**Advisory Board on the Visual Environment
VEB (Minutes)
Tuesday, September 8, 2026 at 7:00 p.m.**

- 1. Sign Extreme, Inc. – Mindset Cannabis Shop – 370 S. Riverside Ave.** The applicant, Tyler Blaire (TB), presented the proposed signage located at 370 South Riverside Avenue. TB explained that, because the property is a corner lot, signage is proposed for two storefronts: one facing Benedict Boulevard and one facing South Riverside Avenue.

Revised sign

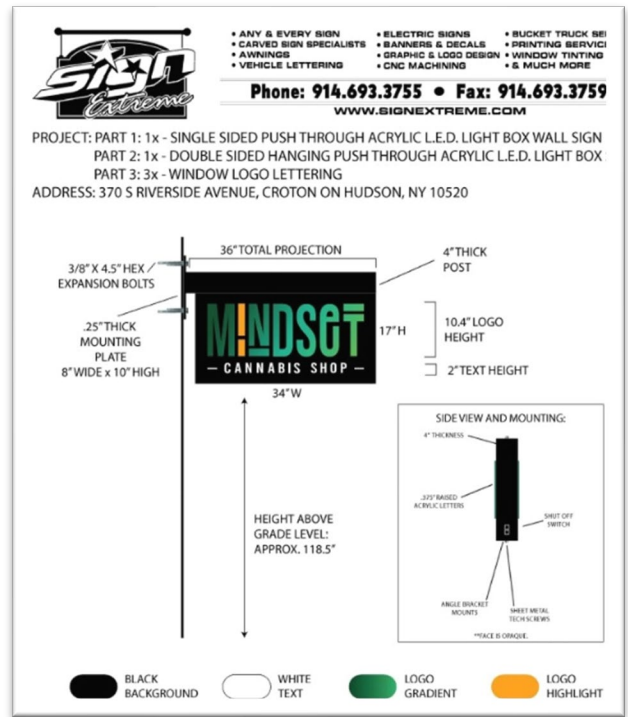
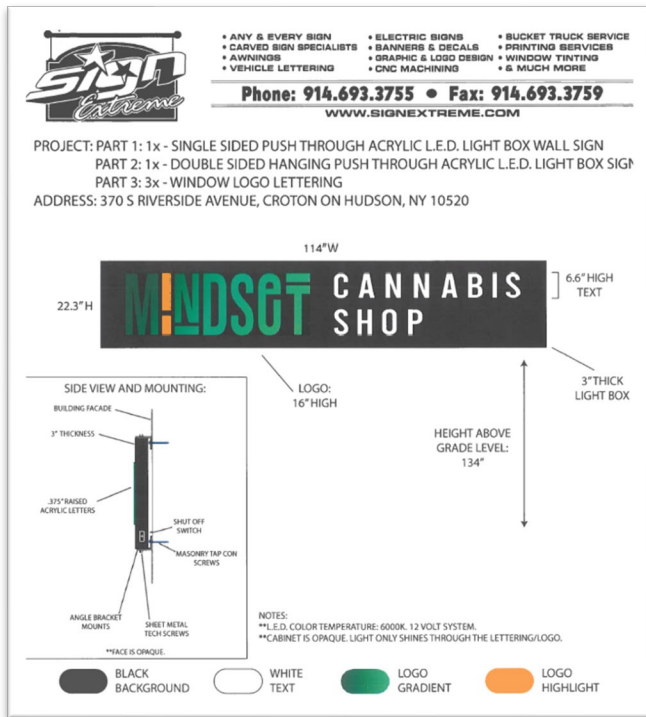
TB clarified that the projecting sign proposed for the South Riverside Avenue storefront had been revised to 36 inches to address the requirements of Village Code Section 230-44 (P)(4)(a)(3). A revised elevation was distributed to the Board members for review.

The board members requested additional samples and clarification regarding the appearance of the signage when illuminated. Questions were also raised regarding how noticeable the proposed signage would be in comparison with other signage in the surrounding area.

AMR suggested that the sign should be consistent with the character of the Village. She indicated that she did not want the signage to be as large as the Pedego Bike sign and suggested that the design be more comparable to a boutique-style storefront sign.

TB discussed other Mindset locations in Airmont and Tarrytown and showed the Board a photograph of the storefront from his phone. Some of the board members indicated they preferred the white-background signage at the Tarrytown location, which featured gooseneck lighting. The owner, Vincent Silvestri explained that the brand logo had since been changed to the logo reflected in the current proposal.

The Board also discussed whether the words “Cannabis Shop” should be incorporated beneath the word “MINDSET” on the proposed Benedict Boulevard signage. One Board member noted that, while driving around and viewing other similar establishments, she had not observed the words “Cannabis” incorporated into the signage of those businesses.

TB explained that the proposed lighting would consist of low-voltage LED lighting, with the light illuminating through opaque acrylic lettering against a black background. He provided samples of the proposed acrylic lettering for the Board's review.

The Board discussed whether the lighting could be placed on a timer and whether a dimmer could be incorporated to allow the brightness to be adjusted if necessary. TB indicated that a timer could be provided for the signage.

Following the discussion and clarifications of the proposal, the VEB members did not agree with the proposed design. AMR indicated she would view the referenced signage the following day and document her findings and email them to the Board for further review.
